Band 10 – Noise Temperature Specification

ALMA CHANGE REQUEST

Date submitted: 2012-04-30
CRE #: FEND-40.02.10.00-0000-A-CRE

TITLE:
Change Request for the Band 10 Cartridge Noise Performance (DRAFT!)

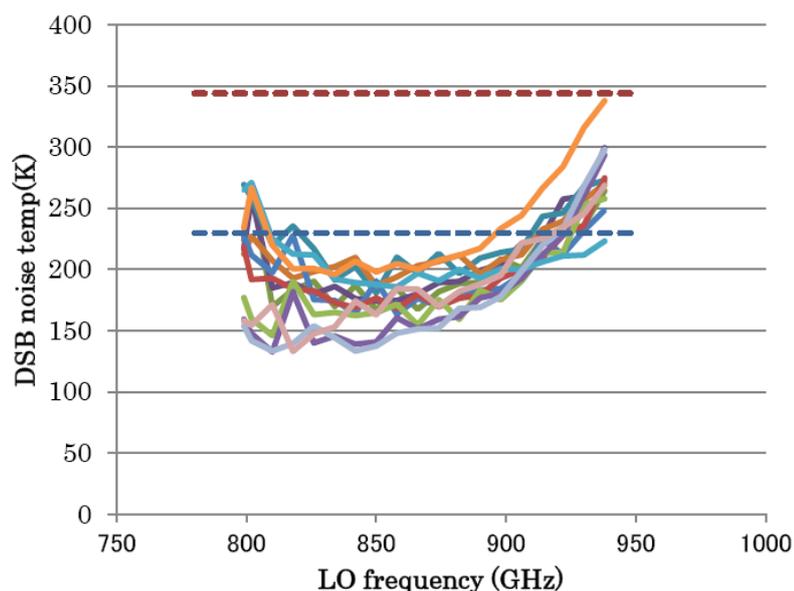
Since then the Band 10 team at NAOJ has devoted an enormous amount of effort to this and has now produced the results shown in this plot for the first 6 dual-polarization cartridges:

Note in particular the different vertical scale compared to the previous plot. This clearly represents a tremendous advance and I believe that we should congratulate the team on these results. It is important to take account of the fact that the frequencies in Band 10 lie

As explained in the attached draft change request, FEND-40.02.10.00-0000-A-CRE_Trx, there is no realistic prospect of reaching a viable yield of mixers if we insist on the original requirement, so some relief is now being sought. After some discussion, the proposed requirement is that the noise temperature should still be below 344 K over the whole band (787-950 GHz) but below 230 K only over 80% of a reduced range of 787 to 905 GHz, (instead of 80% of the whole band). This way of expressing it still allows some margin to allow for the fact that it is not possible to control the parameters of the junctions well enough to put the best spot at exactly the same place in every receiver. It nevertheless means that in practice we can expect that the overall performance of the array will be extremely good (in fact be rather better than that set by the original requirement) over at least the frequency range 800 to 895 GHz.

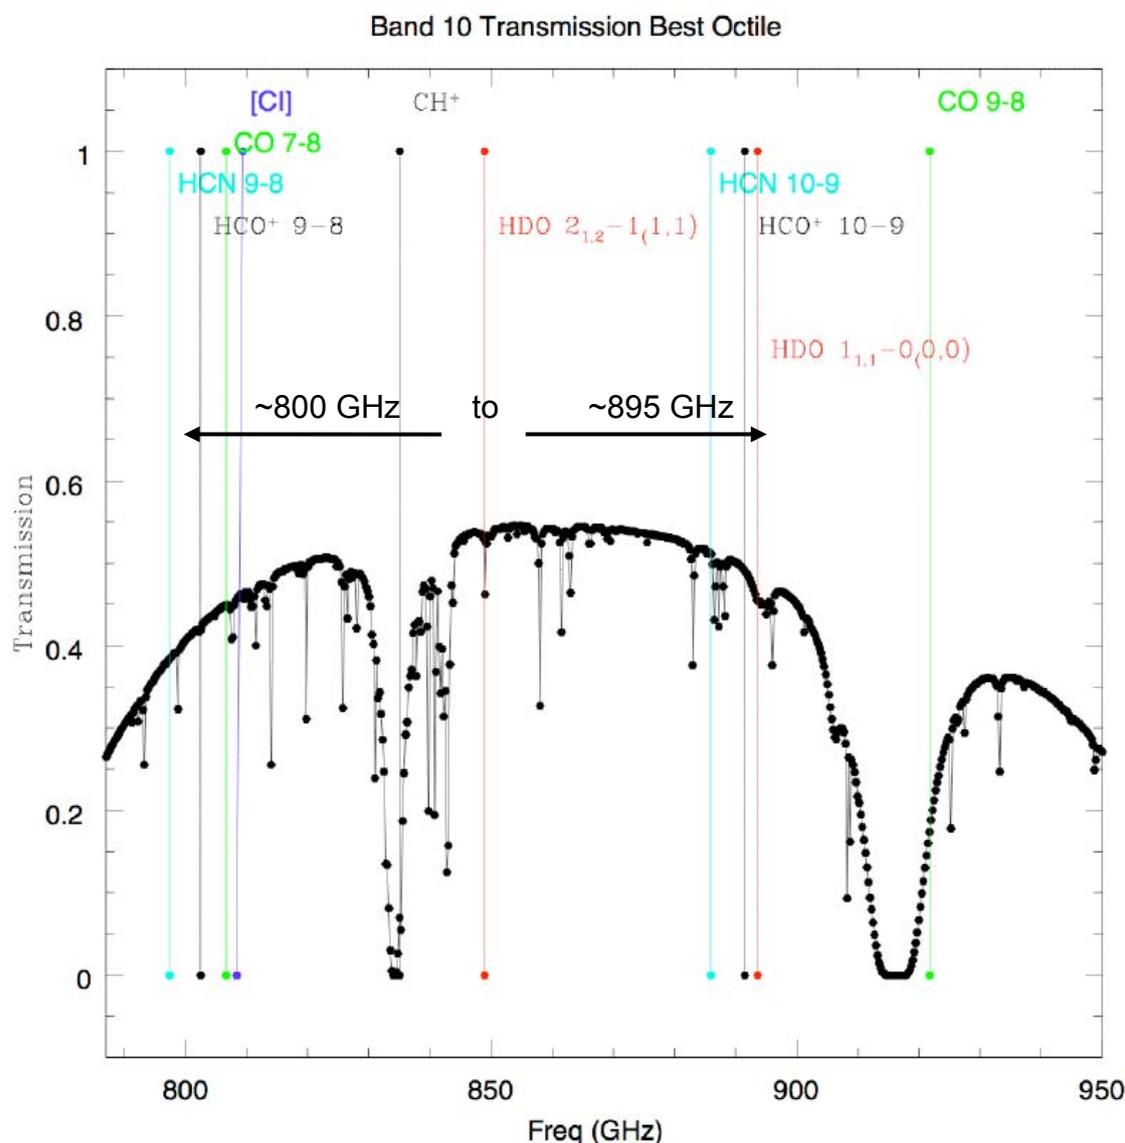
Al Wootten has provided this plot that shows the atmospheric transmission at zenith for about 0.5 mm of precipitable water vapour, together with the important lines, and I have marked the above range of frequencies.

It can be seen that, with the exception of the CO J = 9–8 transition, essentially all the lines are included. (HCN J = 9–8 falls just outside, but the J = 10–9 line is inside.) It is to be emphasized that, at < 344 K, the performance across the whole band will still be extremely good by any standards. The natural choice for continuum observing would be from ~850 to ~880 GHz, which is also inside the region where we would have the best performance.

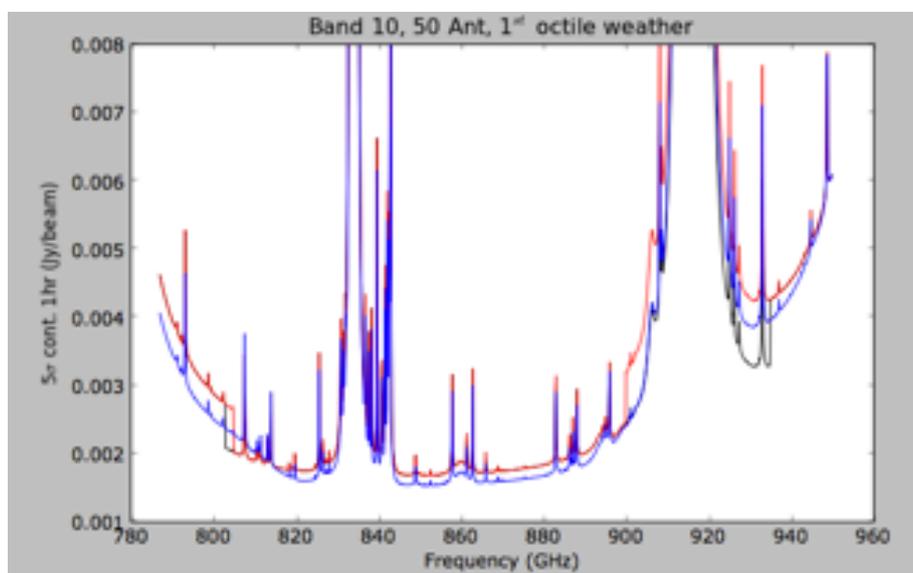
It is important to appreciate at that these frequencies there is a large contribution to the system temperature, and hence to the overall system sensitivity, from the atmospheric emission and that therefore changes in receiver noise have less effect than one might expect. This plot by Andy Biggs illustrates that point. Here the black curve shows the sensitivity expected for a receiver which exactly met the original specification, the red curve the one that exactly meets the proposed revision and the blue curve shows the result for a simple smooth function that is a rough fit to the measured data shown above. This is again under very good conditions (about 0.5 mm of water vapour): the effect would be even smaller if there were more water.

One of the other important topics for this band is observations of red-shifted emission from the C⁺ cooling line. For the whole band, the red-shift range over which this line can be studied is $z = 1$ to 1.41, but with some gaps due to the atmospheric absorption features. With the proposed specification we expect the best region to be from z of about 1.12 to 1.37 with a gap at about 1.275. Access to this line across the whole band will however not be lost by accepting the change request. The main effect is likely to be at about 930 GHz ($z \sim 1.04$), but even there the loss of sensitivity is modest, as can be seen above.

Figure 1. DSB noise temperatures of the first six Band 10 cartridges as a function of LO frequency. A blue dashed-line shows the noise performance specification of 230 K over 80% bandwidth.

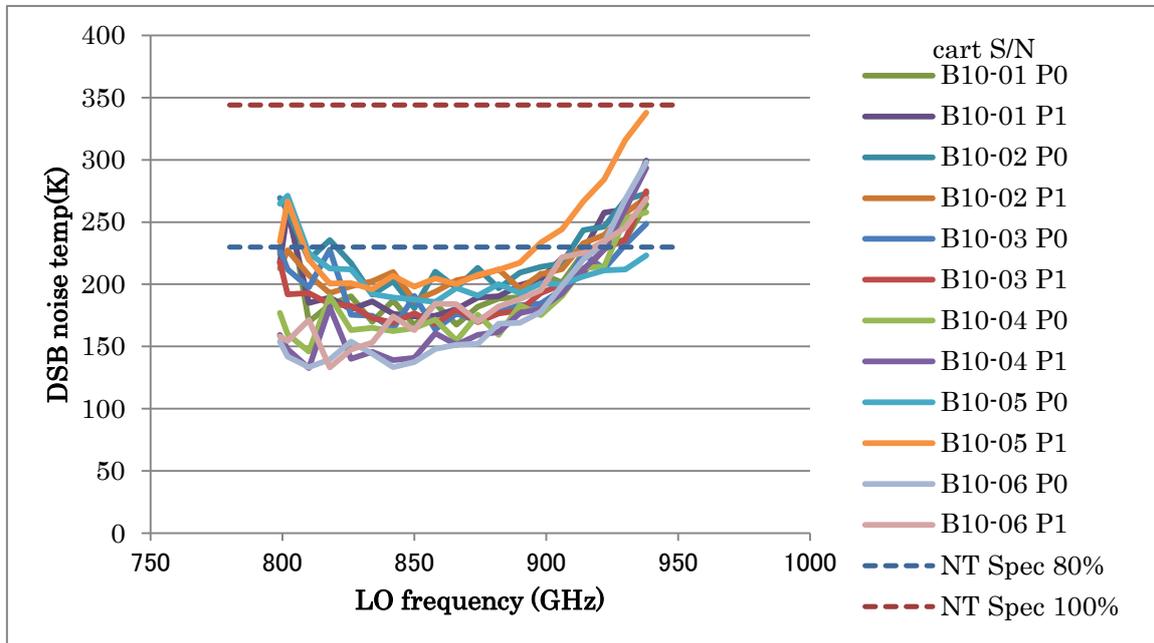
Although all pre-production cartridges are compliant with the requirement of less than 344 K for the bull-band, three cartridges out of six did not meet the specification of less than 230 K over 80% of the band as shown in Figure 1 [RD 01]. Figure 2 shows the noise performance in the worst case, which has 58% bandwidth below 230 K [RD 02].

From 230 K over 80% of the frequency range

To 230 K over 60% of the frequency range

Considering these situations mentioned above, the current noise requirement will need to be relaxed for the production cartridges as: The bandwidth for the 230 K noise requirement is relaxed to over 60% (instead of 80%). Another possibility has been discussed on JIRA [RD04], which is: The noise temperature requirement is relaxed to 250 K (instead of 230 K) over 80% bandwidth. The 100% bandwidth noise specification could stay the same. It should be noted that the proposed new specification or the second option would still be challenging.

Figure 2. Noise performance of CCA10-05 Pol. 1 (the worst case of 58% bandwidth in the first six cartridges).

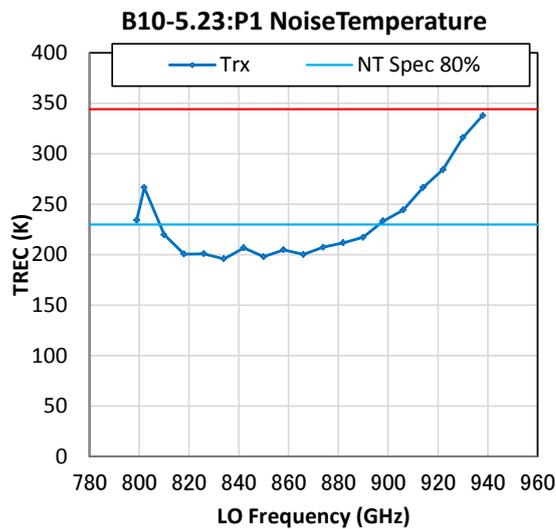
Another cause to increase the noise performance is thought to be excess LO noise. For example, in Figure 2, the noise increase at ~800 GHz can be seen, which may be due to the excess LO noise. The corresponding noise can be observed in measurements of noise temperature versus IF and LO frequency, as shown in Figure 3. This noise could be reduced by using a quasi-optical LO attenuator with a smaller diameter hole (larger attenuation). But simultaneously, the LO power to pump the SIS mixer will be decreased. Figure 4 shows an SIS pumped current as a function of LO frequency in full LO power operation as an example. The red line with closed squares shows optimum pumped currents for the receiver operation. The use of lager LO attenuation in the LO path would improve the receiver noise performance by decreasing the excess LO noise, but the noise performance at around 920 GHz is degraded due to a lack of LO power. Thus, it is difficult to improve the noise performance over all by changing the quasi-optical LO attenuator. More power-full LO sources will resolve this issue, as seen in the case of lower frequency bands. Or reduction of excess noise in the LO source will be necessary. However, the current LO technology limits these improvements.
